INDESIT company

Model type:
AQCF852BIEU

Commercial code:
F061523

07471-05 Exploded views

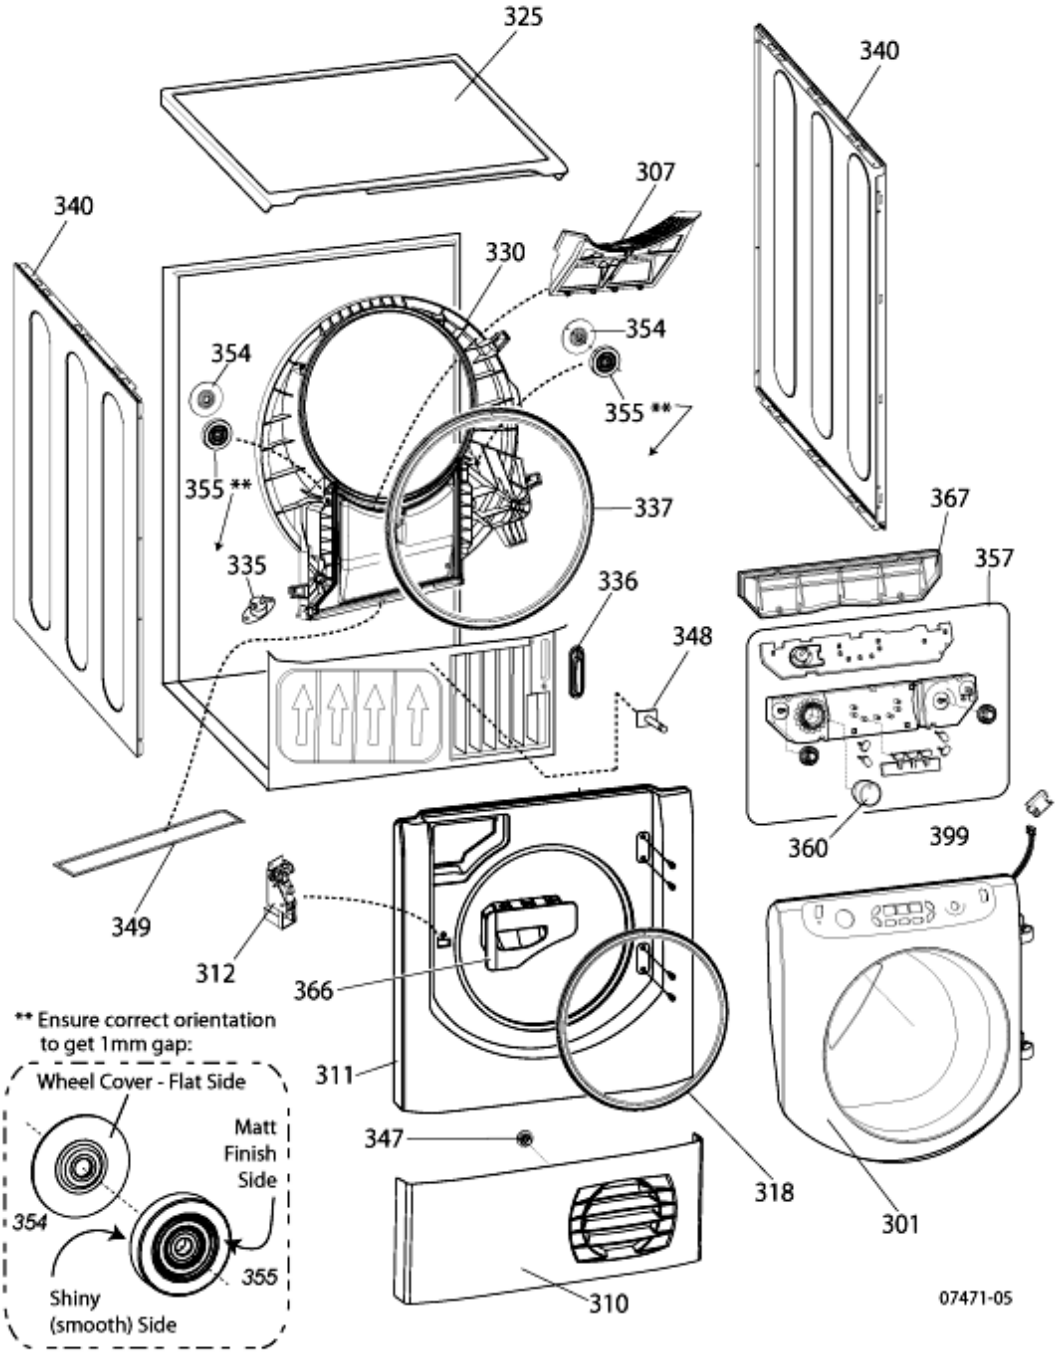
n4409k01: Introduction of Interface Module with Stand–By

From serial number 91102.0001 a new interface module with ‘Stand-By’ was introduced on production and is fitted to all electronic tumble dryers. The "Stand-By" mode is activated after the machine has finished the programme. This module can be used as a direct replacement for the version without Stand-By.

n4411g02: AQUALTIS TUMBLE DRYERS FILTERS

FROM JUNE 2011 THE FLUFF FILTER FITTED TO AQUALTIS TUMBLE DRYER CHANGED IN PRODUCTION FROM GREY TO WHITE.
SELECTED THE CORRECT PART BY DESCRIPTION IN THE PARTS LIST

07471-20 Exploded views

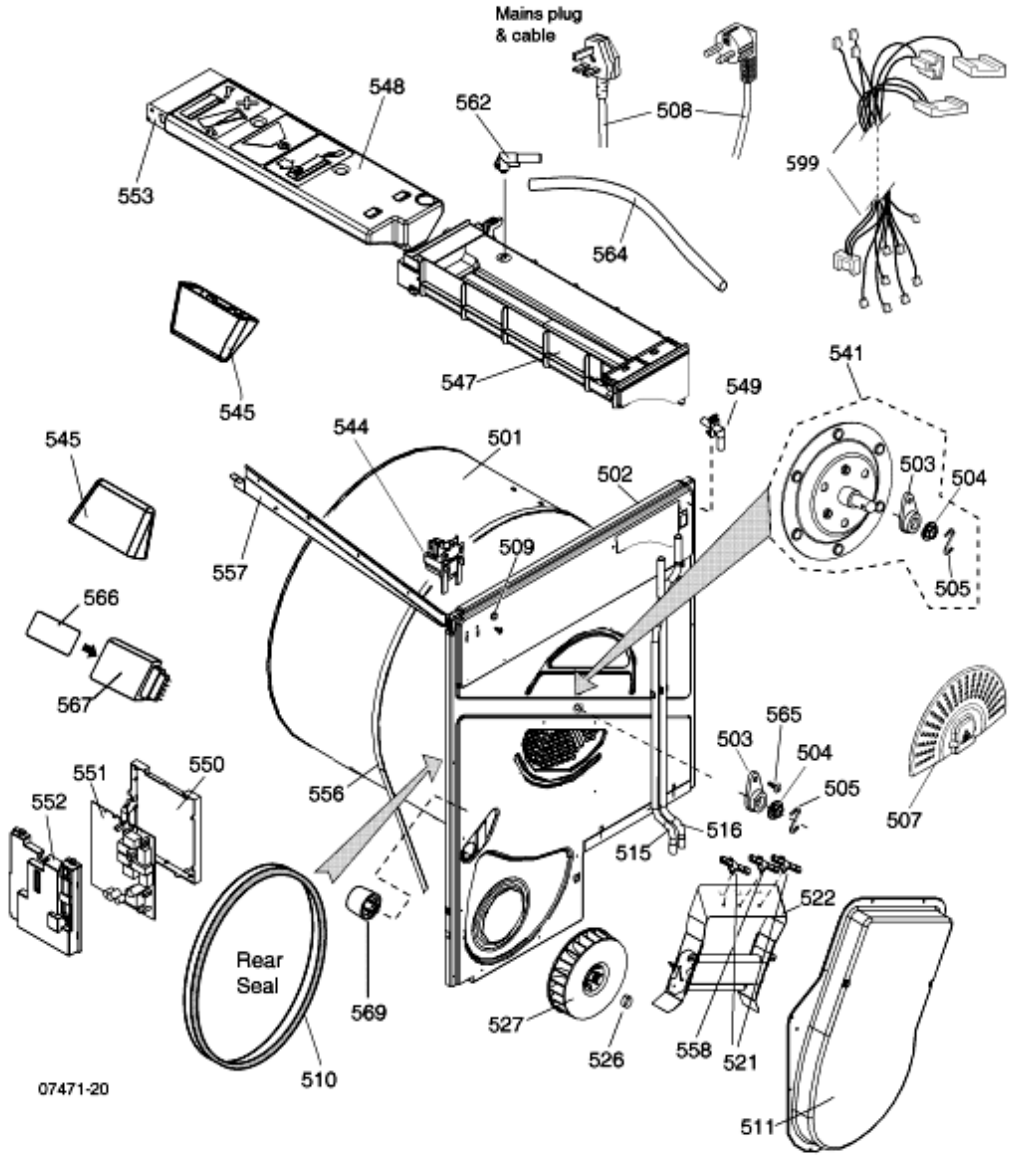
n4413j00: BREAKING BELTS

To overcome the issue of breaking belts the 6 Rib belt has been replaced by the 8 rib belt C00300793

07471-25 Exploded views

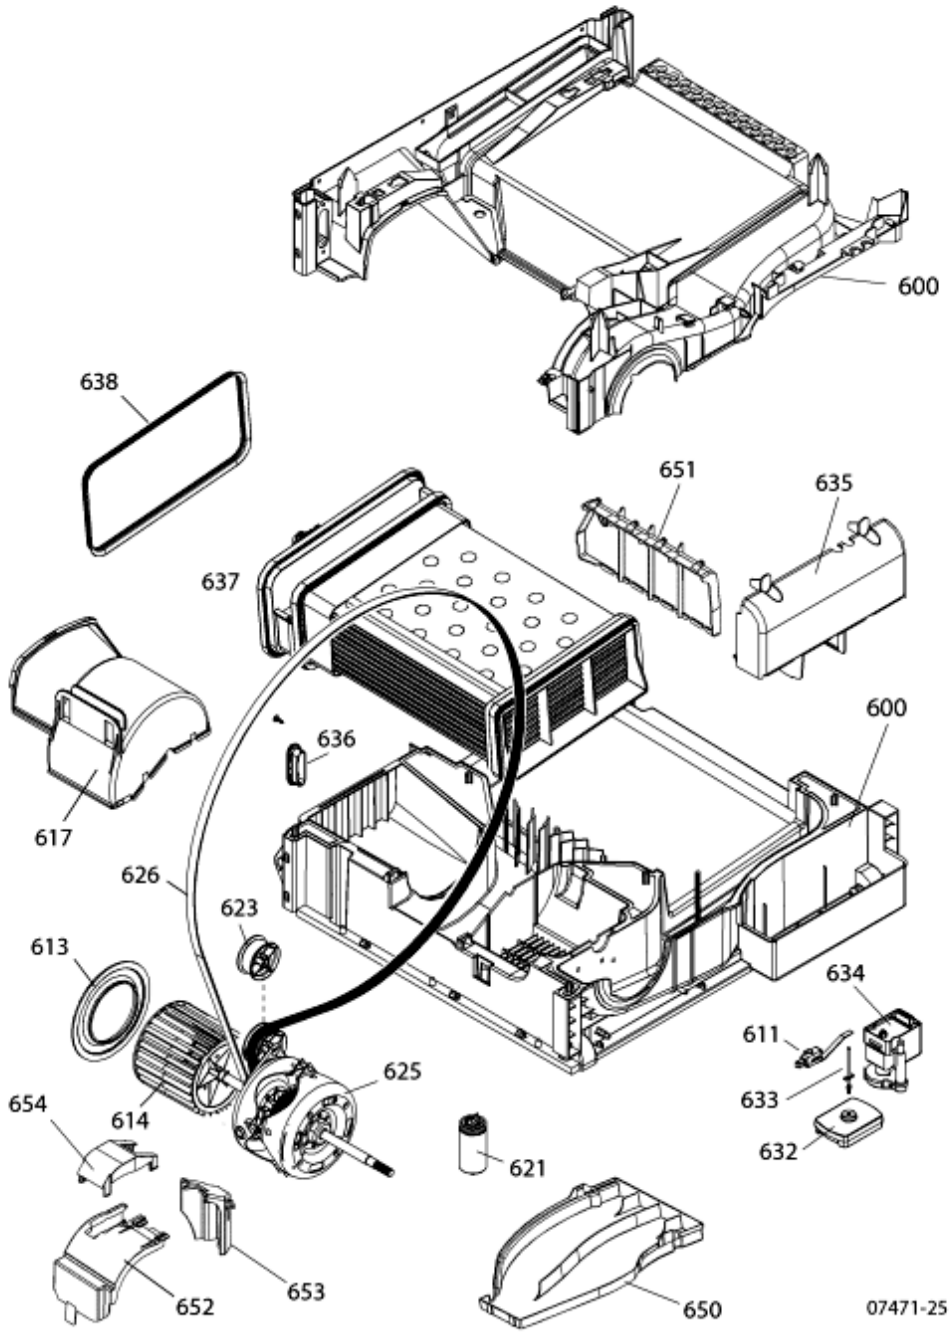
n4409i00: B ENERGY COOLING FAN/INLET RING

B ENERGY and 7 Kg MODELS

From Serial Number 90929.0001 a 72mm Cooling Fan and Fluted Inlet Ring have been used in production.

A kit including a 72mm Cooling Fan and Fluted Inlet Ring must be used on models before serial number 90929.0000 if either part requires replacing.

n4410f01: 350 MOTOR AND B Energy BOM Changes

350 MOTOR
THE 350 motor once current stock is exhausted, will no longer be available.
The 356 motor with a 9.5uf Capacitor is a suitable replacement.
CAPACITORS
When replacing a capacitor, the motor fitted must be first identified.
350 MOTOR 8.5uF
362/363 MOTOR 8.5uF
356 MOTOR 9.5uF
THE CORRECT CAPACITOR MUST ALWAYS BE FITTED.

From 16/08/2010, Serial No.0816.0001 the build of some 7.Kg, 7.5Kg & 8Kg level 2 and level 3 B Energy rated condenser dryers changed to a new B Energy build using an A2 control module with 4.5.14 firmware along with a new type 362 motor and 2.3Kw insulated heater assembly. The base unit is based on the Aqualtis B Energy but using the C Energy type condenser unit with the base duct and motor covers removed.

n4412c02: B ENERGY CAPACITORS

WHEN REPLACING A CAPACITOR THE MOTOR FITTED TO THE MACHINE MUST BE IDENTIFIED FIRST.
350 MOTOR 8.5uF
362/363 MOTOR 8.5uF
356 MOTOR 9.5uF
372/373 Motor 8.5uF
392/363 Motor 8.5uf
THE CORRECT CAPACITOR MUST ALWAYS BE FITTED.
